APPLICATION NO.	FILING DATE	FIRST NAMED INVENTOR	ATTORNEY DOCKET NO.	CONFIRMATION NO.
10/580,205	02/22/2007	Rudolf Heid	2360-0448PUS1	1643

Office Action Summary	Application No. 10/580,205	Applicant(s) HEID ET AL.	
	Examiner STEPHANIE JENNINGS	Art Unit 4135

DETAILED ACTION

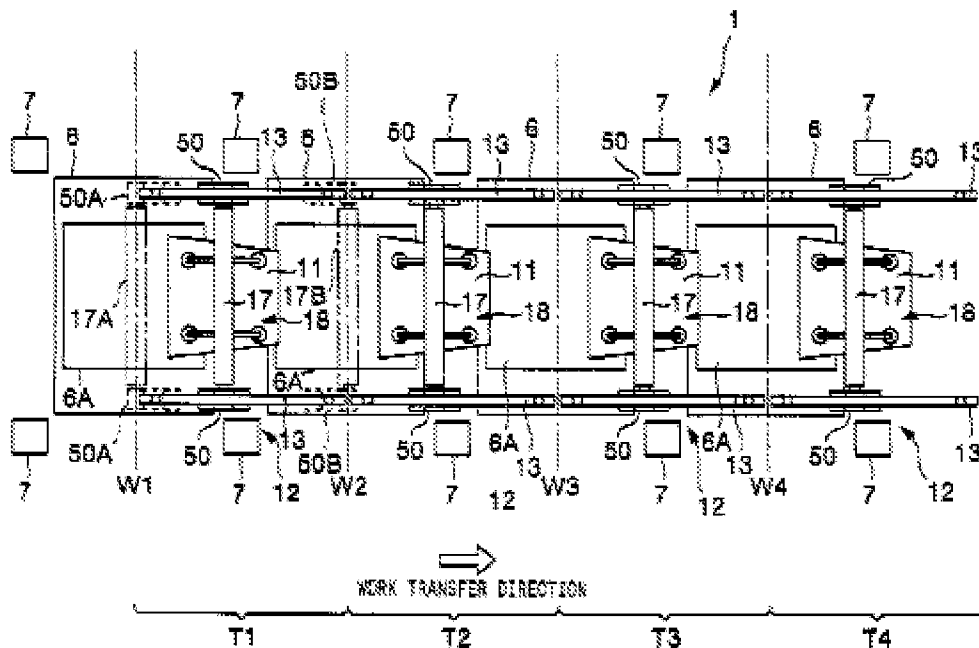
11. Claims 1, 2-4, 5, 12, and 14-17 are rejected under 35 U.S.C. 103(a) as being unpatentable over Kawamoto US Patent Application Publication 2003/0084701 A1 (cited in Applicant's IDS), VanderZee et al. US Patent No. 5,979,212 and Darr et al. German Patent No. DE 4101513 A1.

13. Limitations from claim 1, a conveyor for transporting work pieces in a press, in particular a multiple-die press (2), from a first station (W1) to a second station (W2) adjacent to the first station (W1), comprising a) at least one lateral beam (13) arranged on a side of the press, essentially extending parallel to a transport direction of the conveyor (1); b) at least one bar (17) having grippers (15—not shown in figure 1 above) for gripping the work piece to be transported, whereby the bar (17) is attached to the lateral beam (13) in such a way that it is movable along a longitudinal extension of the beam (13); and c) for each lateral beam (13) an assembly (7) for supporting the lateral beam (13) (pages 1-2, paragraph 13).

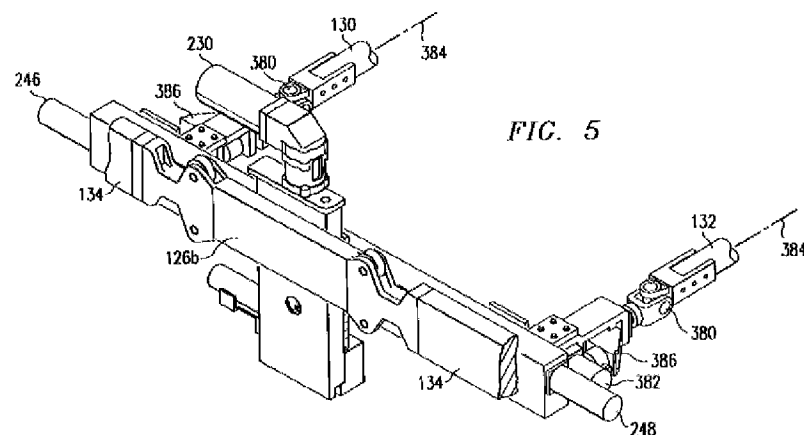
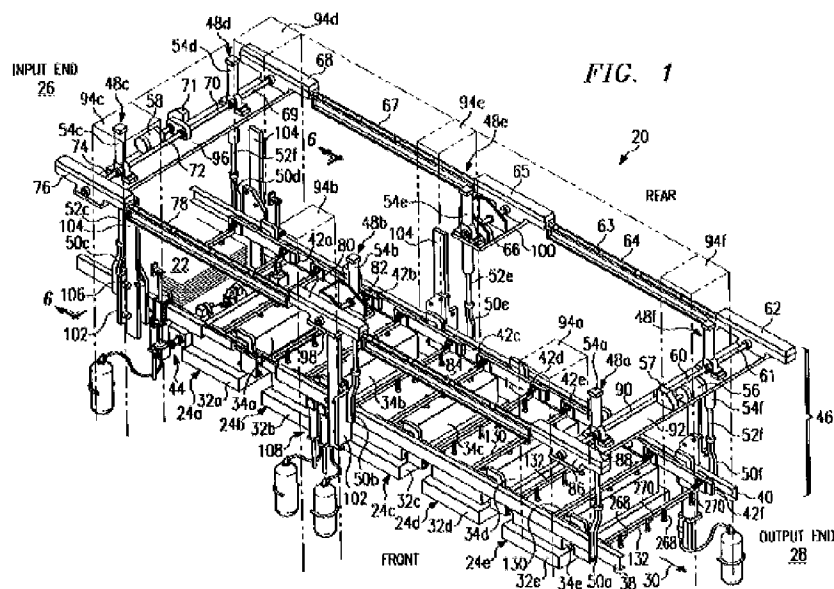
19. Limitations from claim 12, a conveyor system for transporting work pieces in a press line or multiple-die press, comprising a plurality of conveyors (W1-W4) according to claim 1, arranged consecutively (pages 1-2, paragraphs 13-14).

20. Limitations from claim 13, the conveyor system according to claim 12, characterized in that two consecutive conveyors (W1, W2) are arranged such that the work piece (11) may be handed over from a first of the conveyors (W1) to a second of the conveyors (W2), whereby the work piece (11) is flipped (pages 1-2, paragraphs 13-16).

21. Limitations from claim 14, A method for transporting work pieces in a press, in particular a press line or multiple-die press, from a first station (W1) to a second station (W2) adjacent to the first station (W1), employing a bar (17) attached to a lateral beam (13) arranged on a side of the press, extending parallel to a transport direction, comprising the steps of: a) positioning the bar (17) above the work piece (11) situated in the first station (W1); c) gripping the work piece (11) by grippers (15) attached to the bar (17); e) transporting the work piece (11) to the second station (W1) by moving the bar (17) along a longitudinal extension of the beam (13); and g) disengaging the work piece (11) from the grippers (15) (pages 1-2, paragraphs 13-16).

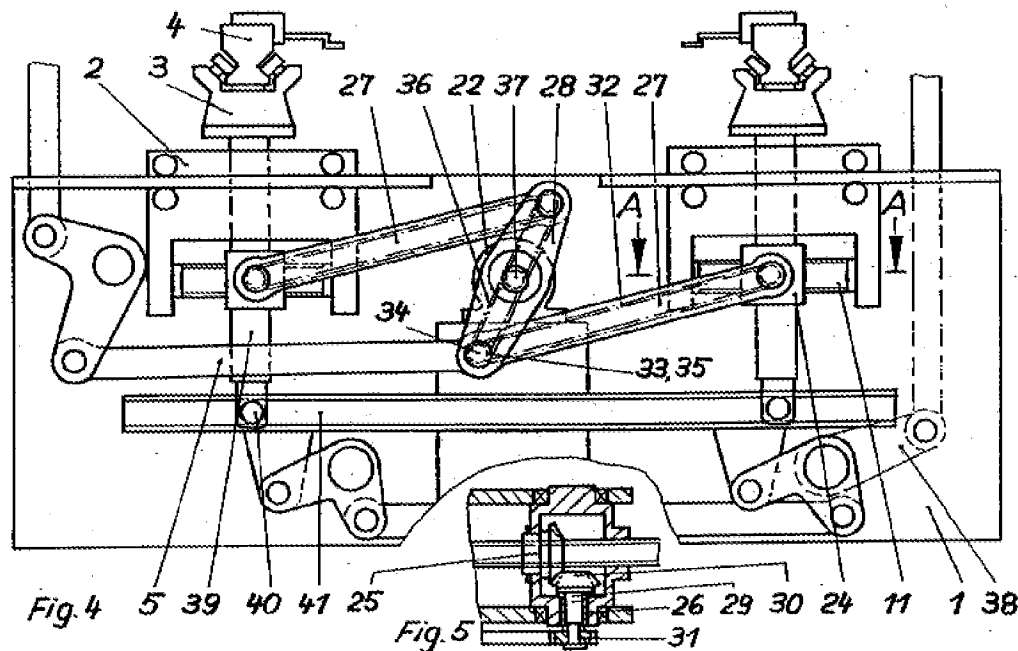
25. Limitations from claim 1, a conveyor characterized in that d) the assembly (20) comprises a pivoting mechanism (figure 5) (column 2, lines 42-54, column 3, lines 16-19, 28-34 and column 3, line 64-column 4, line 6).

26. Limitations from claim 2, the conveyor according to claim 1, characterized in that the pivoting mechanism (figure 5) is formed such that the pivotal axis crosses a vertical plane

comprising the lateral beam (38, 40), either through (384) the lateral beam (38, 40), in particular close to a middle portion of the lateral beam (38, 40) (column 3, line 64- column 4, line 6).
